9.2 NO. 188 (LOT: 1; D/P: 33790) VINCENT STREET, NORTH PERTH - PROPOSED ALTERATIONS AND ADDITIONS TO PLACE OF WORSHIP

To consider an application for development approval for alterations and additions to the Redemptorist Monastery and Church at No. 188 Vincent Street, North Perth (the subject site).

MEZZANINE
EXISTING PLAN
SCALE: 1:100

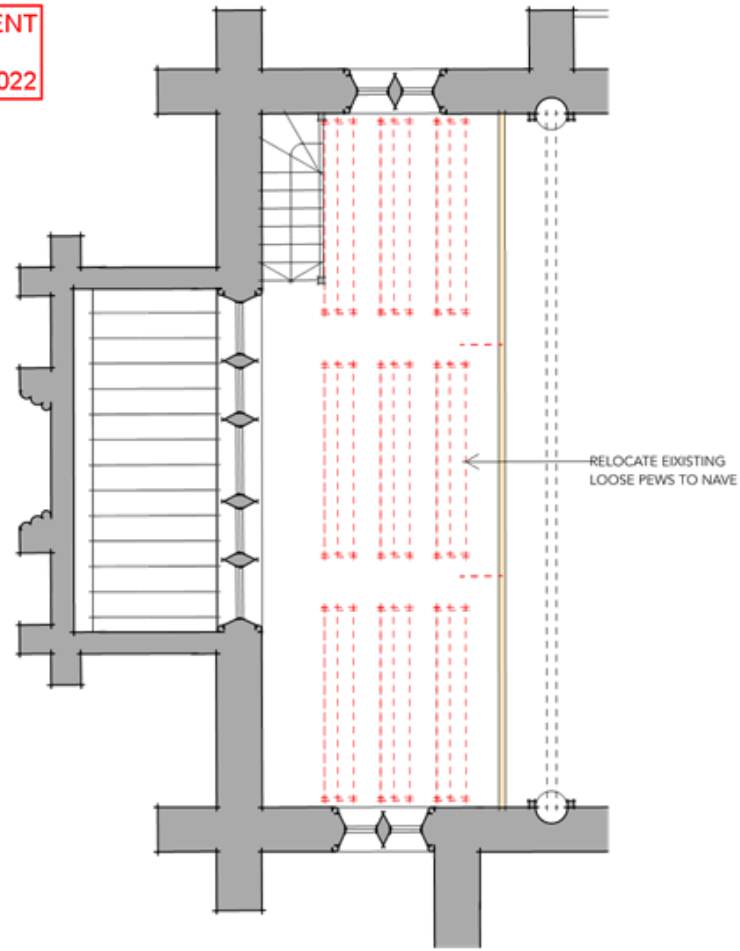
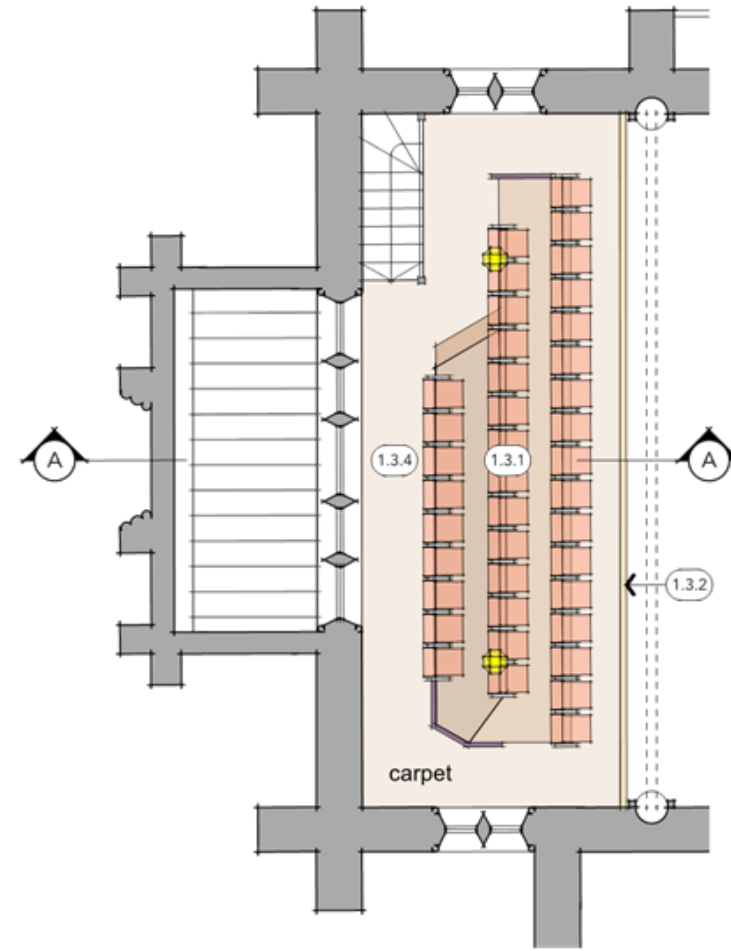
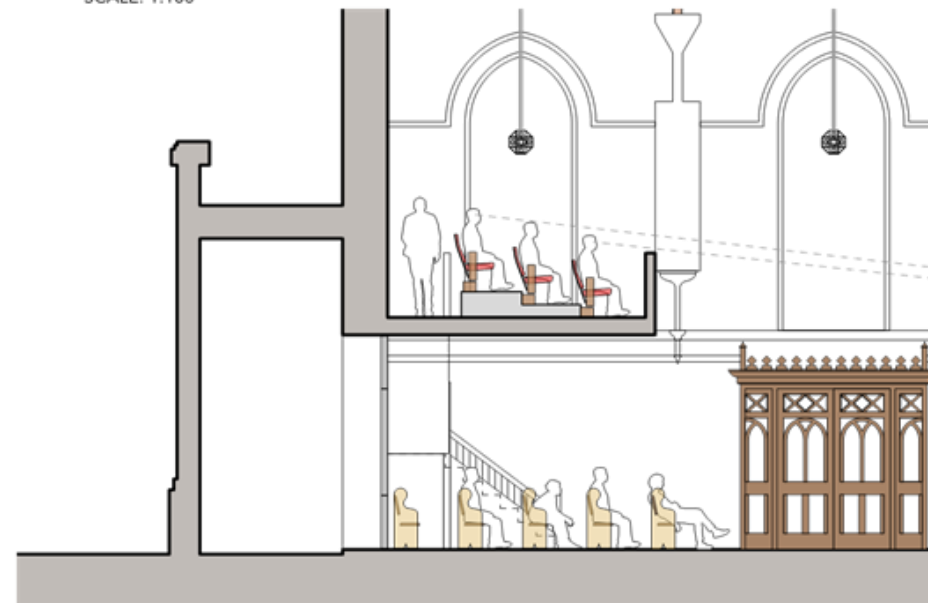
- Choir Gallery: The Choir Gallery is noted in the Conservation Plan as being in a fair – poor condition. The proposed works would improve the usability of the space by introducing a rake to the seating. Existing pews within the Choir Gallery would be retained and relocated on-site. The introduction of improved seating would contribute to the ongoing use of the Church for religious worship;

NARTHEX
WESTERN ENTRANCE PLAN
SCALE: 1:100

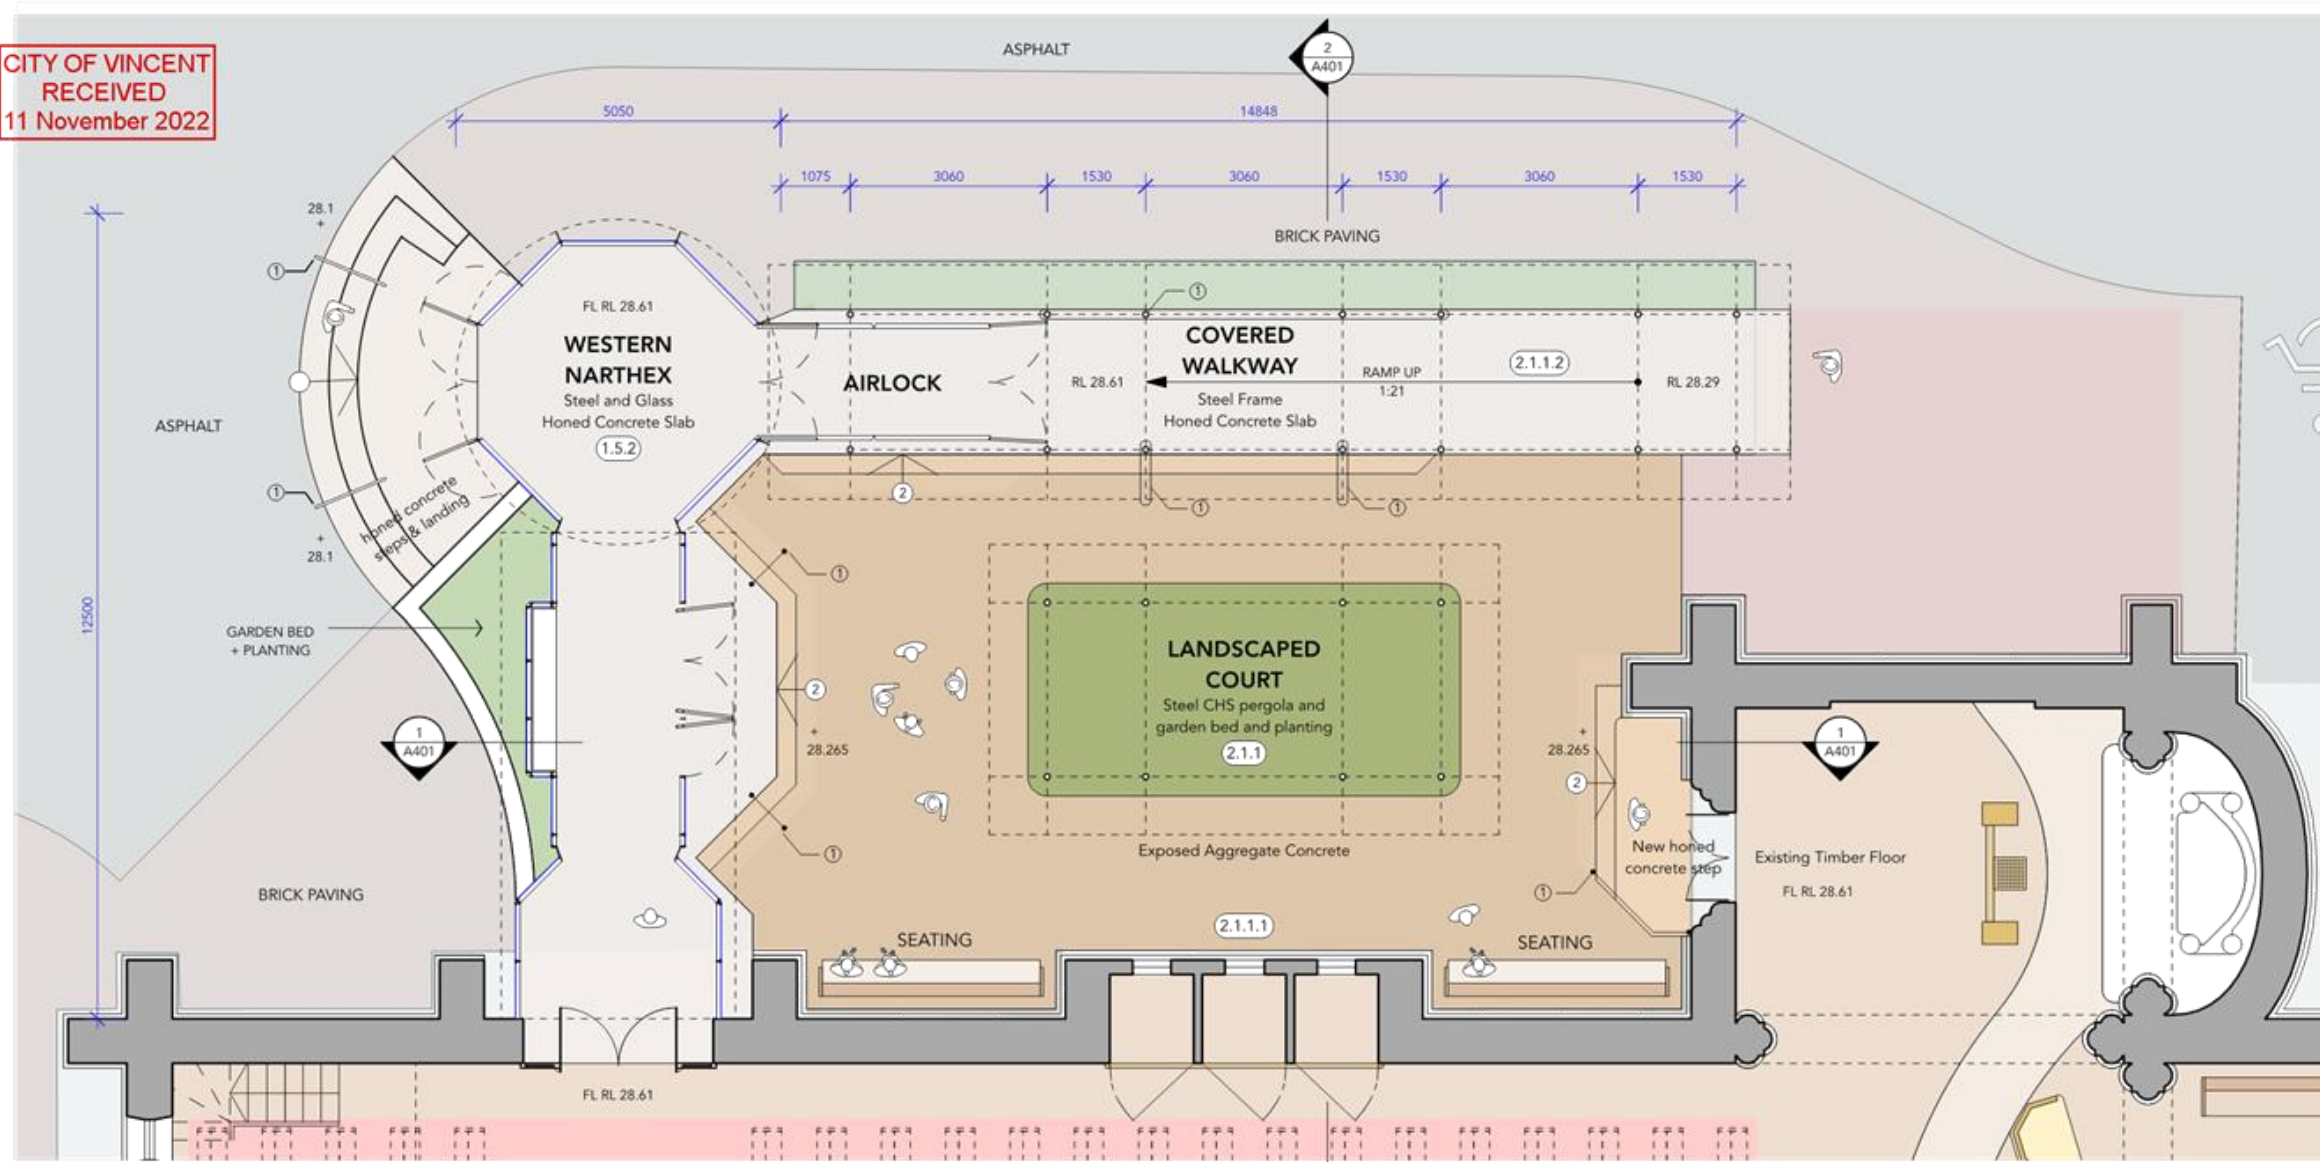
- Glazing to Narthex: The applicant has amended the plans to show the glazing to the Narthex and enclosed walkway to be clear laminated glass. The glass is discussed further below in the Comments section.
- Landscaping to Car Park: Following the conclusion of advertising, the applicant deleted the reconfiguration and expansion of the car park from the application. Except for the car bays removed immediately to the west of the Church to enable the construction of the proposed entry, the car park would remain as existing. As there are no car park expansion works, new trees are not proposed within the existing car parking area.

- The proposed Narthex would be clearly identifiable as new work. It is a lightweight independent structure that would not impose on the Church. The copper domed roof would be in-keeping with transepts and is contemporary in design. The Narthex is designed in a manner that is sympathetic to the Church building and would not have a negative impact on the heritage values of Redemptorist Monastery and Church;

- The removal of the confessionals and constructing a new western entrance would be sympathetic to the heritage fabric of the place and assist Church access. While views of the western façade would be impacted, this is considered acceptable due to the improved access benefits;
- The form and materiality of the Narthex would be sympathetic to the aesthetic heritage values of the Church. Steel, glass, and a standing seam copper roof combine to form a material palette that will be complementary to the Church materiality; and
- The open style contemporary structure will not impact on the cultural heritage values of the Church.

3.2 The glazing to the covered walkway and Narthex shall provide a minimum of 70 percent visible light transmission to provide unobscured visibility;

**WESTERN OPENING TO NARTHEX
ELEVATION**
1:50

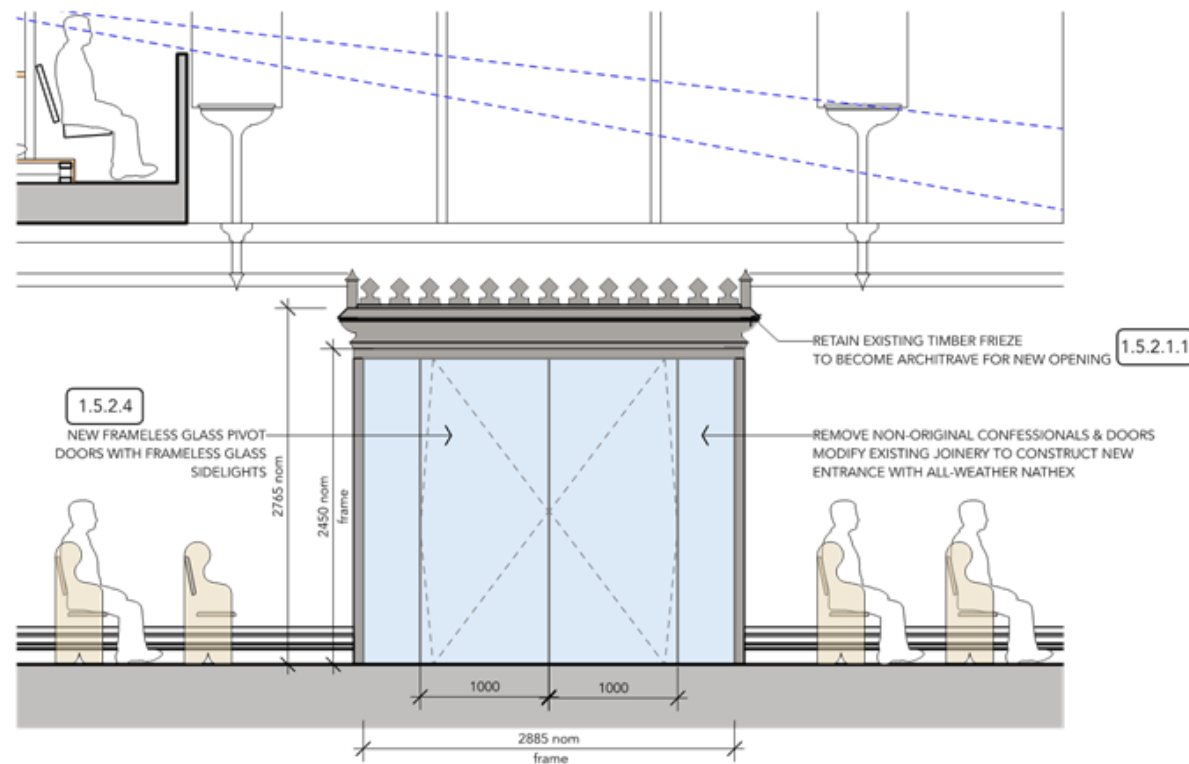
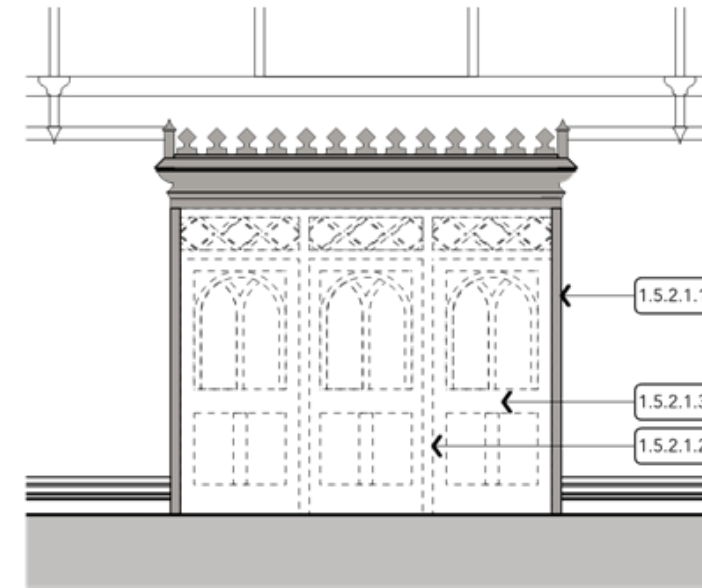
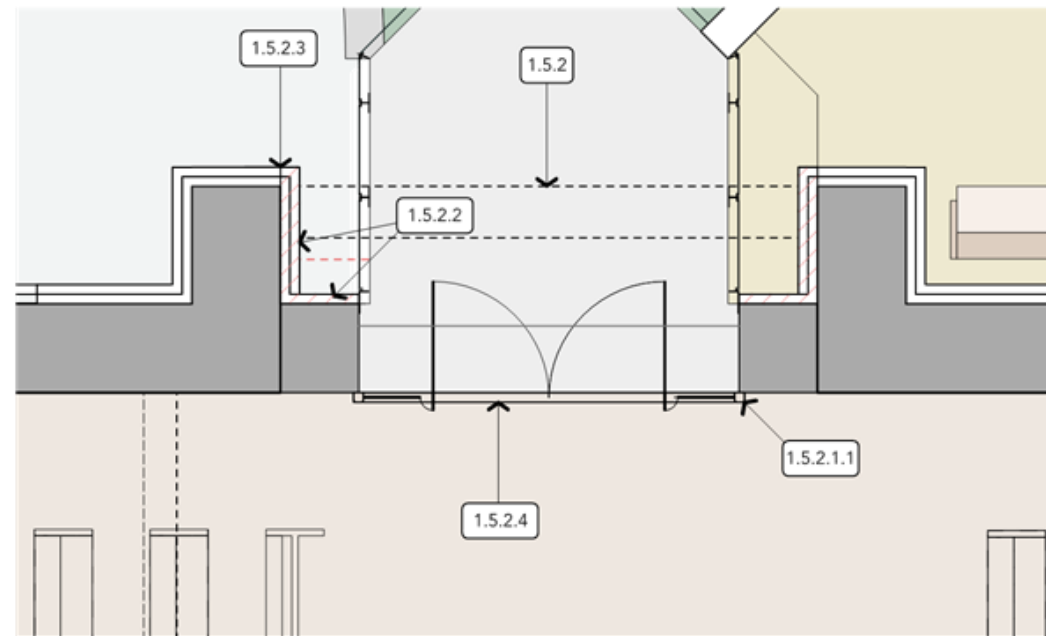
- The removal of the southern confessional on the western elevation would return that part of the building to an earlier state and would have minimal impact on the original heritage fabric of the Church;

- Demolition of the Confessionals and New Entry: The application proposes the demolition of the southern three confessionals to the western elevation which were a later addition to the original Church. The confessionals were categorised in the Conservation Plan as being of 'some' significance given their small scale and status as a later addition. The demolition of the confessionals is supported for the following reasons:

The deconstruction of the confessional and new openings to the Tribune Screen wall shall be undertaken with care. As much of the fabric as possible, including limestone should be retained for reuse, to the satisfaction of the City;
